Model	N810	Volt/Hz	Date of Modification	Serial Number
Modified Article	Parts Catalog			
Reason for Modification	Parts catalog correction

MODIFICATION BULLETIN NO. 3

MODIFICATION BULLETIN NO. 5

MODIFICATION BULLETIN NO. 8

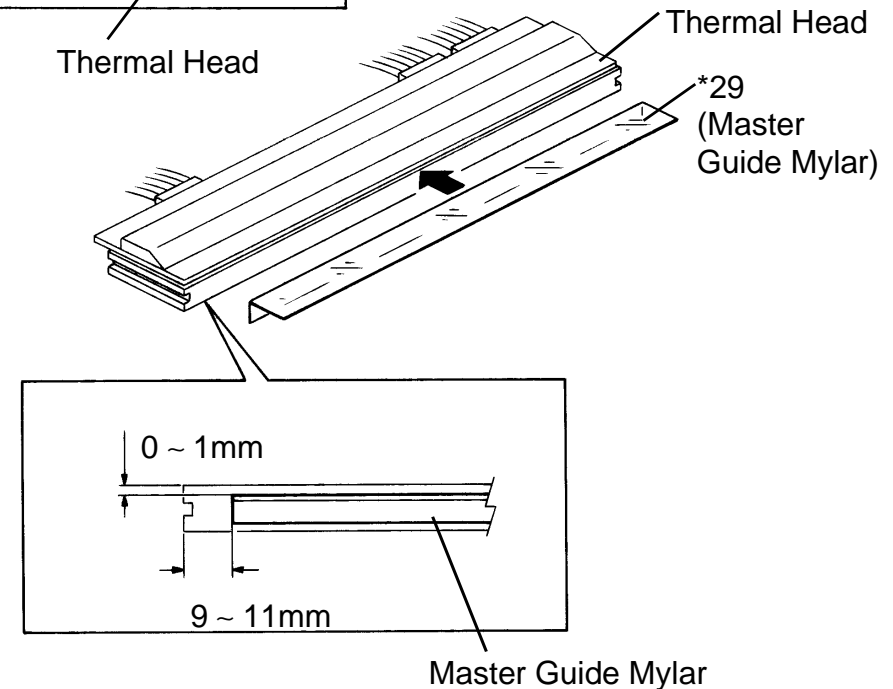
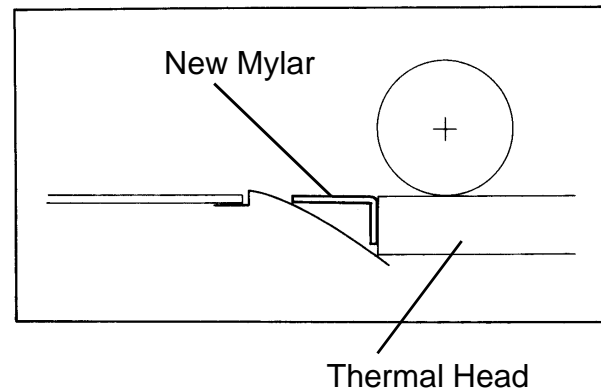
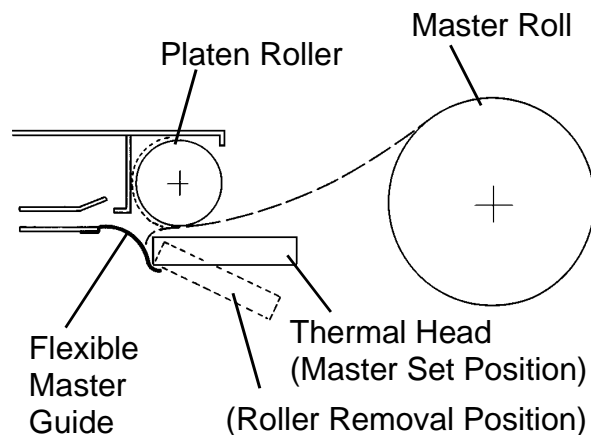
There are two positions for the thermal head release lever: one is to set the master and the other is to remove the platen roller. If an operator mistakenly uses the roller removal position for the master set, the leading edge of the master tends to hit the flexible master guide as shown below. As a result, after the master cut button is pressed, the master will wrinkle and wrap around the platen roller. To guide the master smoother, a strip of mylar has been added on the thermal head.

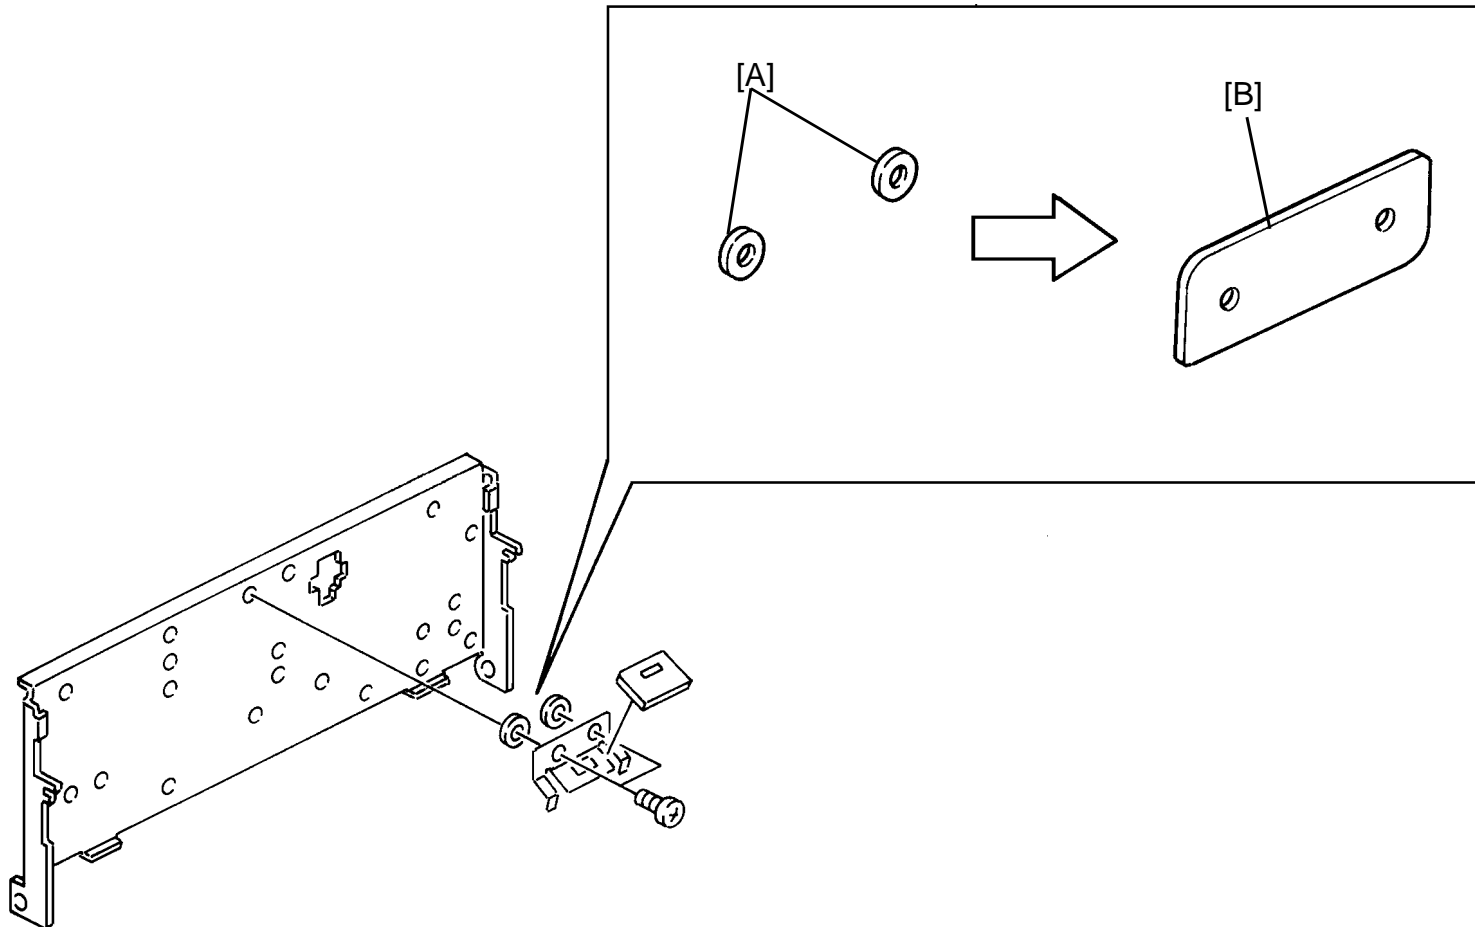
To facilitate assembly, the ADF friction pad spacer has been changed from two washers [A] (These washers are not listed on the parts catalog, but being installed from the 1st production.) have been changed to a thin square plate [B].

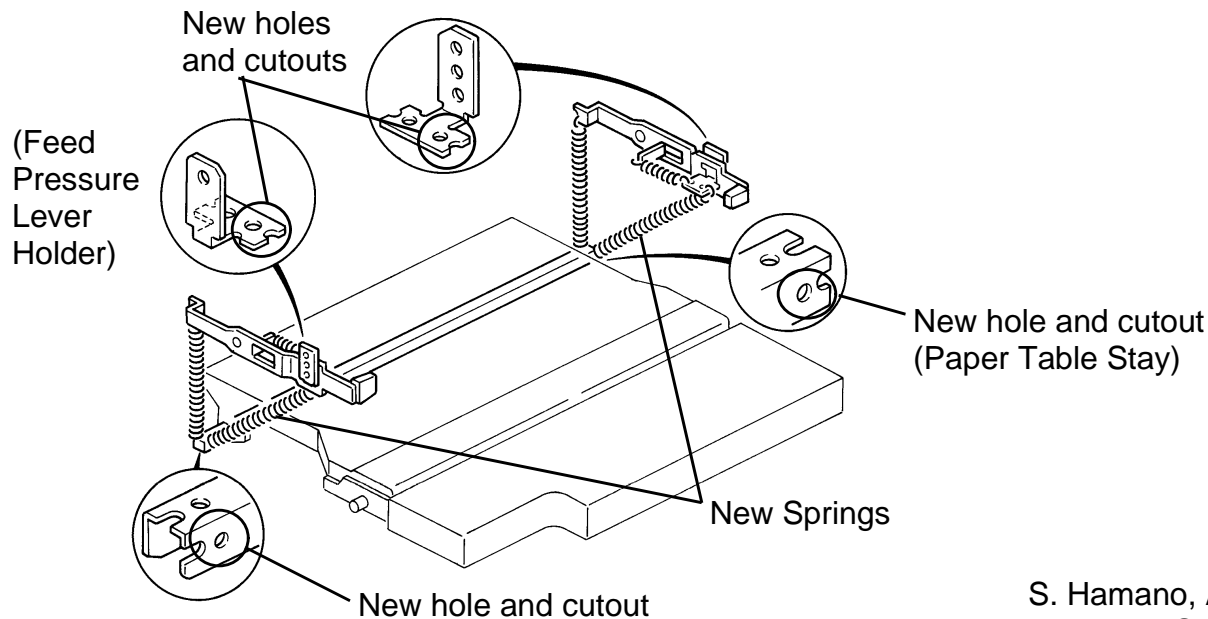
With the current paper table lifting mechanism, paper misfeeds may occur when the pressure adjustment levers are in the upper position (the weak paper feed pressure position) and 500 sheets of standard paper (80 g/m² or 20 lb paper) are set on the paper table. To ensure the paper stack capacity even with the weak paper feed pressure position, two springs have been added. To hook the springs, holes and cutouts have been added to the paper table stay and feed pressure lever holder as shown below.

NOTE: Due to this modification, the pressure adjustment levers have been returned to the upper position in the factory (this is now the factory setting). As in the past, set the levers in the lower position when paper misfeeds occur and return them to the upper position when paper multifeeds occur.

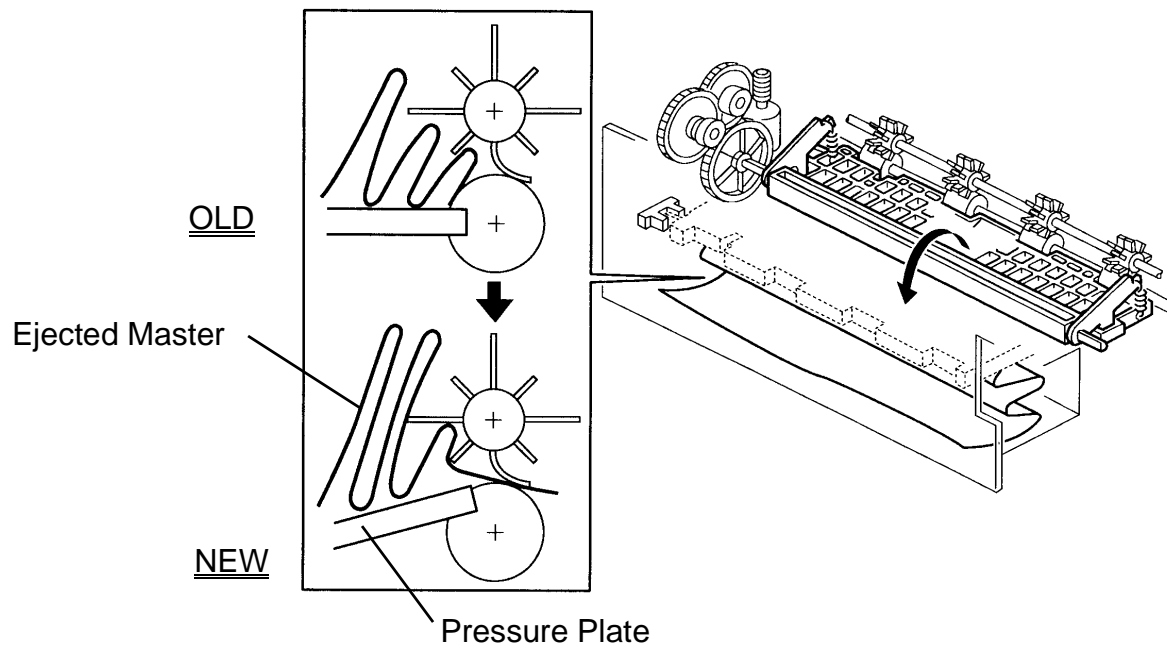
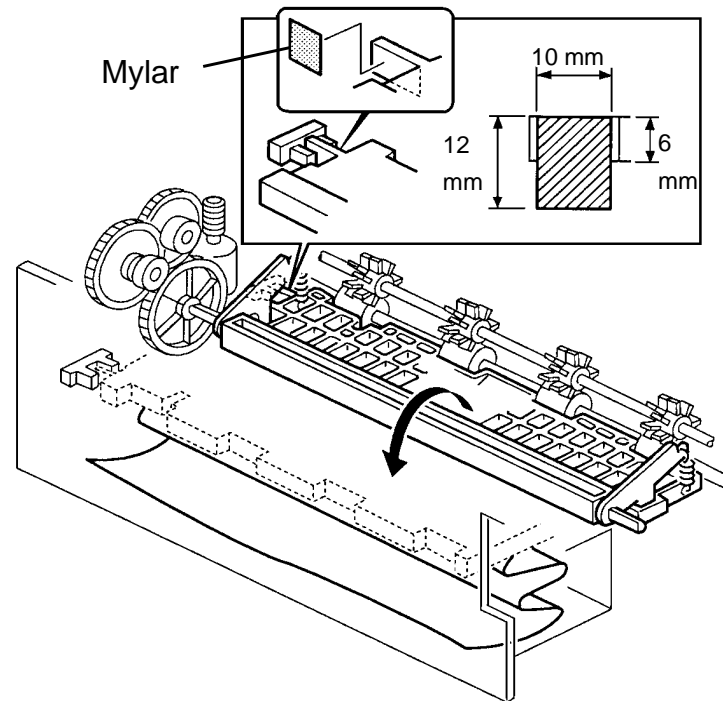
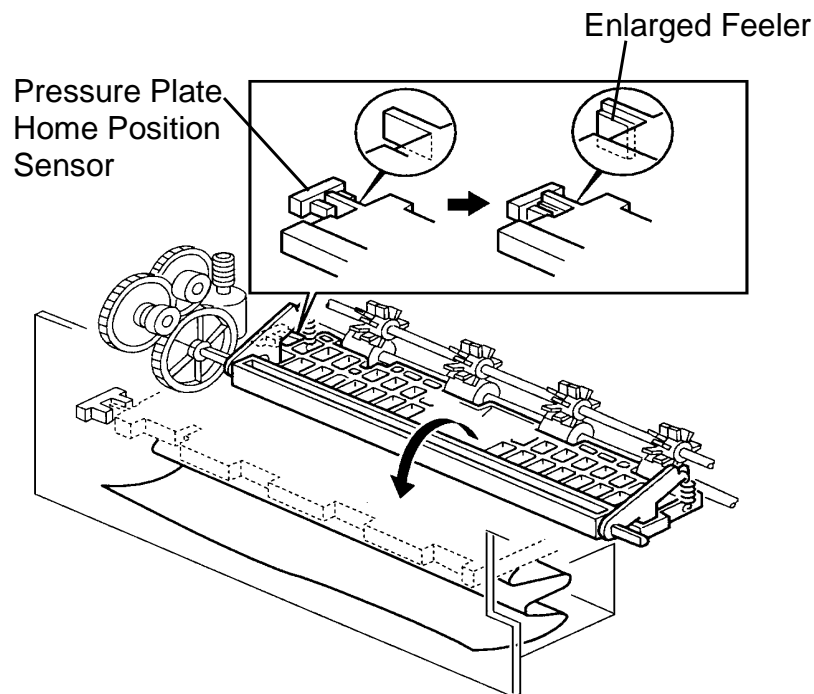
It was found that the ejected master can be fed by the eject rollers more smoothly if a pressure plate is placed just below the upper eject rollers. (See the illustration below.) With the current pressure plate position, the trailing edge of the ejected master tends to be caught by the lower eject rollers.

To enable the pressure plate to stop slightly higher than the current position, the feeler in the pressure plate, which is detected by the pressure plate home position sensor, has been enlarged as shown below left. The enlarged feeler is detected by the sensor earlier than the current type, causing the pressure plate to stop just below the upper eject rollers.

For the field units, the same effect can be obtained by attaching a strip of mylar on the feeler (see the illustration below right).

1. The mylar must not be transparent and must be detected by the pressure plate home position sensor.
2. The size of the mylar must not exceed that indicated in the illustration. If the mylar is too large, the pressure plate will stop at too high a position and will interfere with the ejected master transportation.

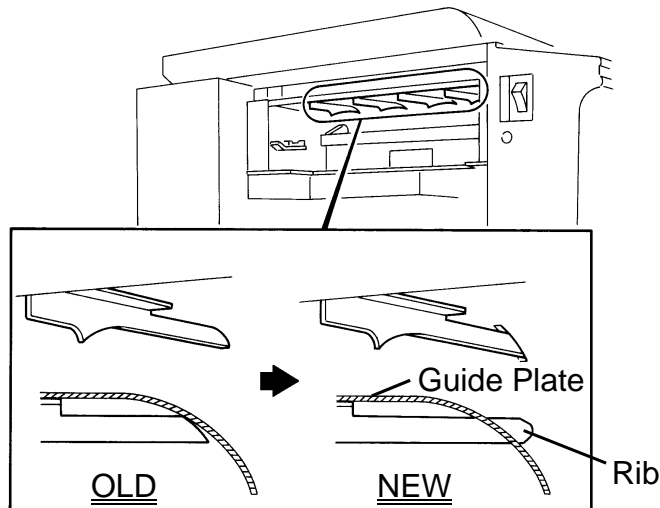
To prevent master eject jams, the ribs fixed to the guide plate have been changed as shown below. For details, refer to RTB-004.

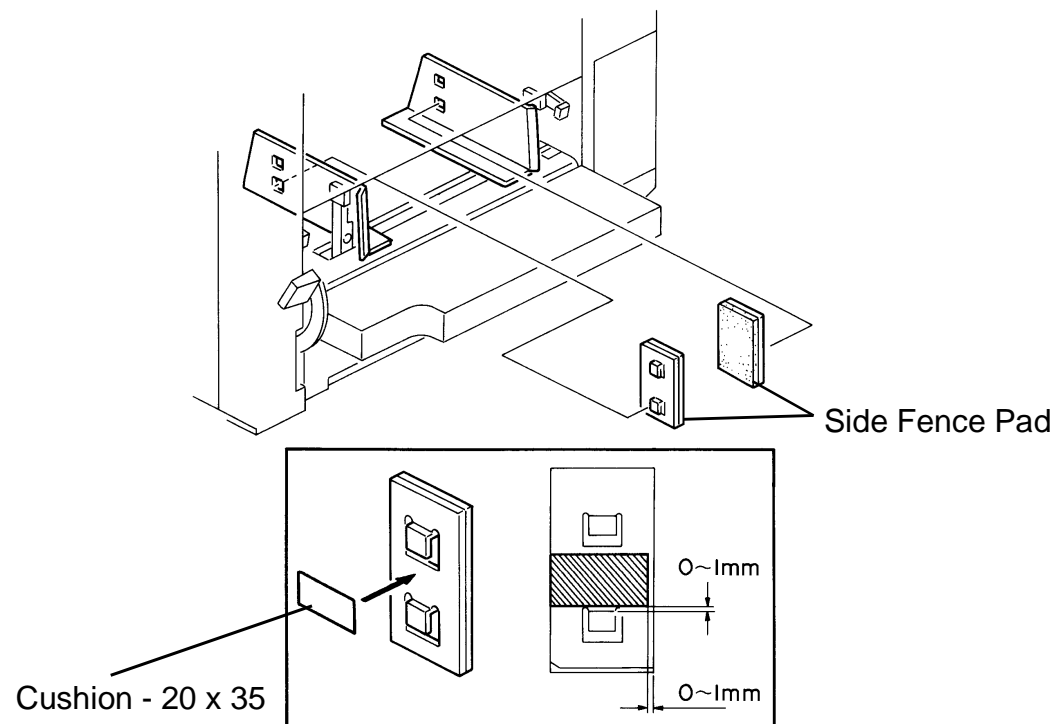
To fit the side fence pads (accessories of the machine) to the side fences firmly, a cushion (C2175017) has been added to each side fence pad as shown below. The new side fence pad (C2175019) includes the cushion.

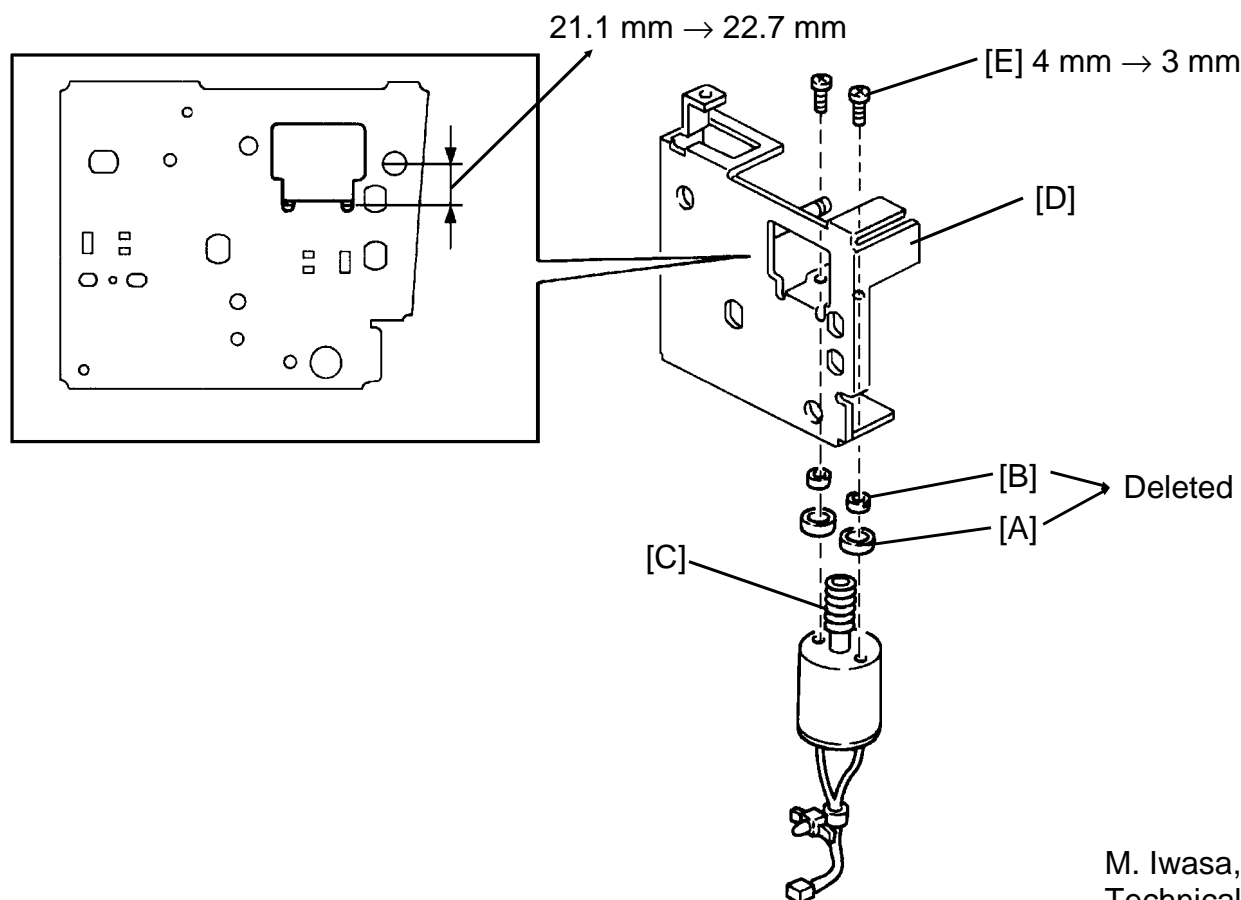
As a permanent solution of the modification described in MB-07, the material of the pressure motor's worm gear [C] has been changed from a combination of metal and plastic to metal.

Due to this, the right side plate [D] has been returned to the previous type, and the bushings [B] and insulators [A] are no longer used. The screws securing the motor [E] have also been returned.

Drawing No.2

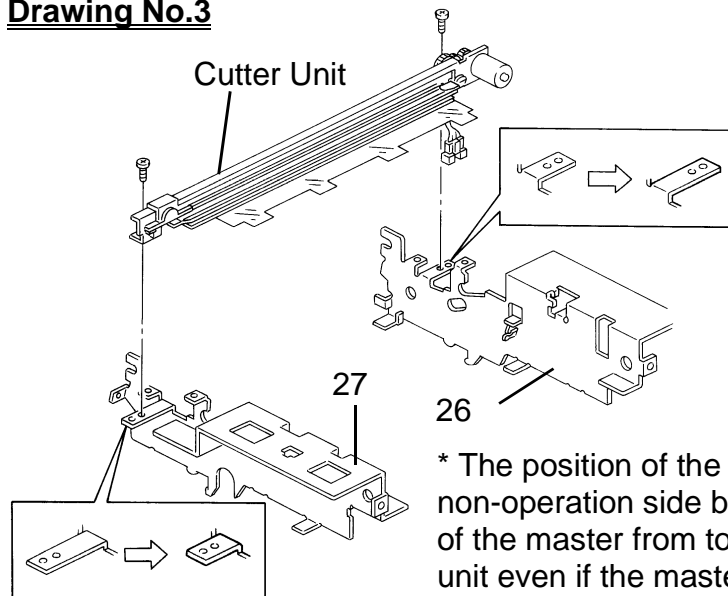
* Step 4 has been added to instruct the operator to rotate the master roll back slightly before setting the platen roller. This is to prevent creasing of the master.

Drawing No.3

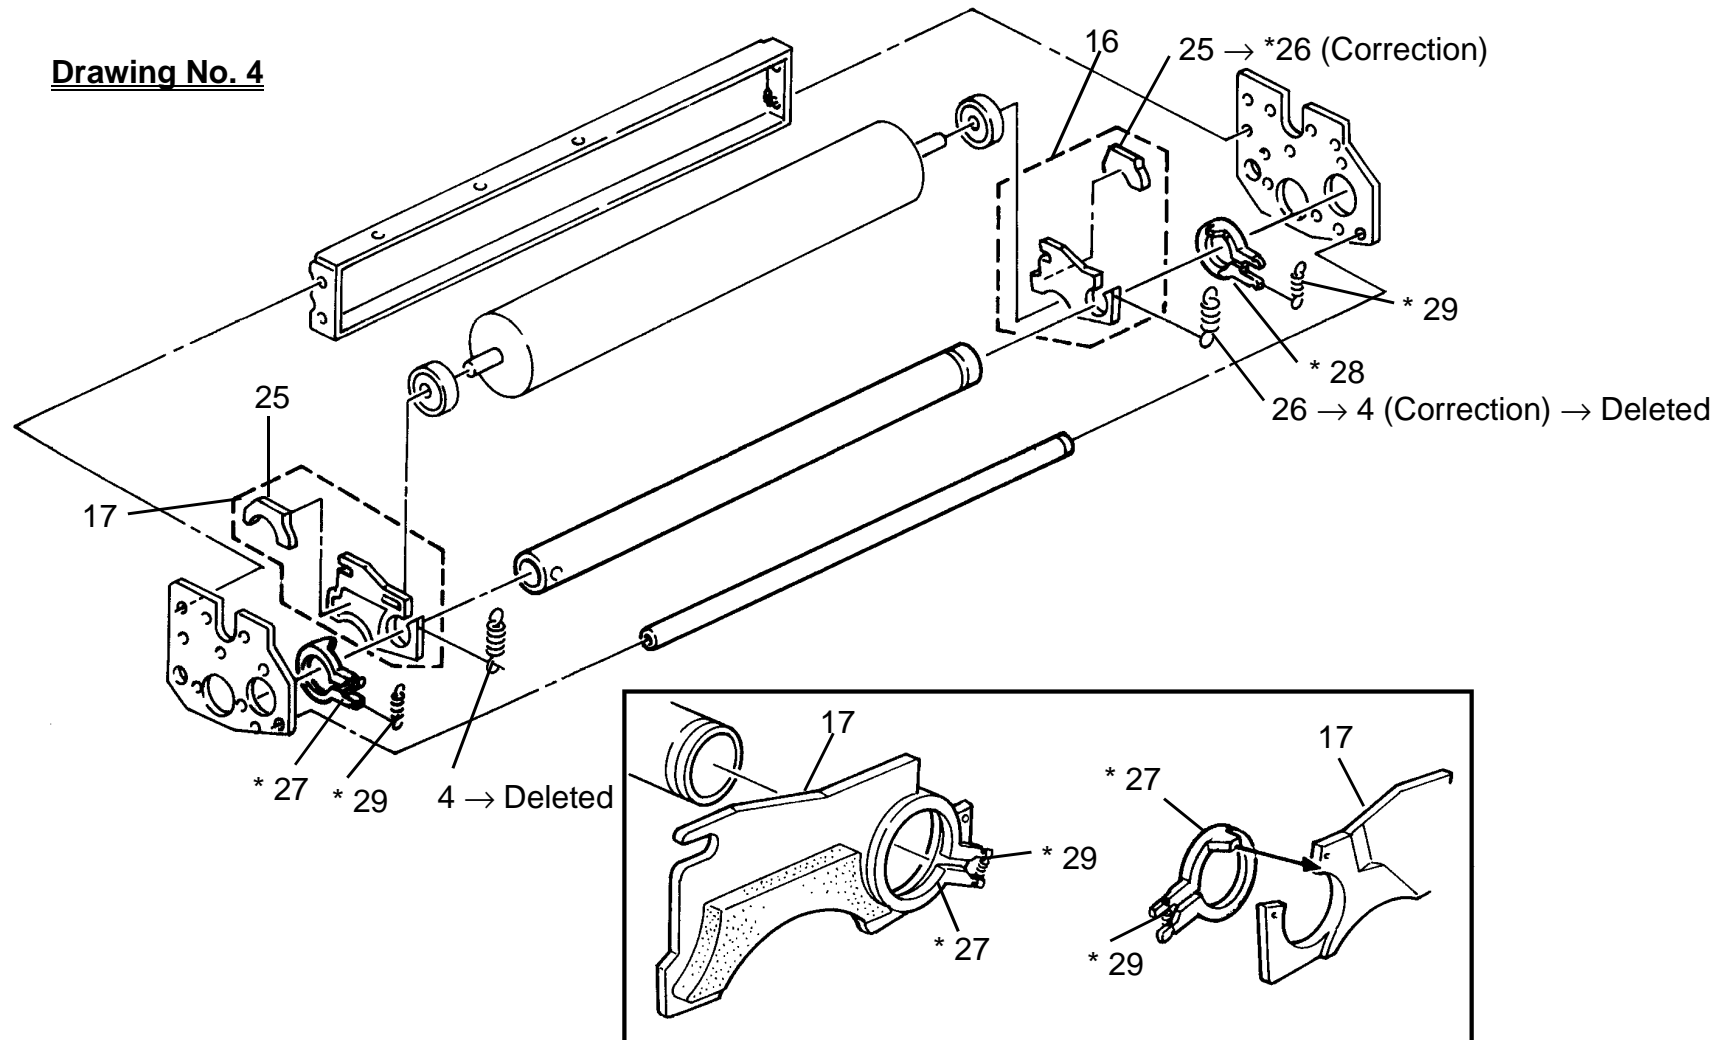
* The position of the cutter unit has been shifted to the non-operation side by 3 mm. This is to prevent the edge of the master from touching the guide plate in the cutter unit even if the master is set at a skew.
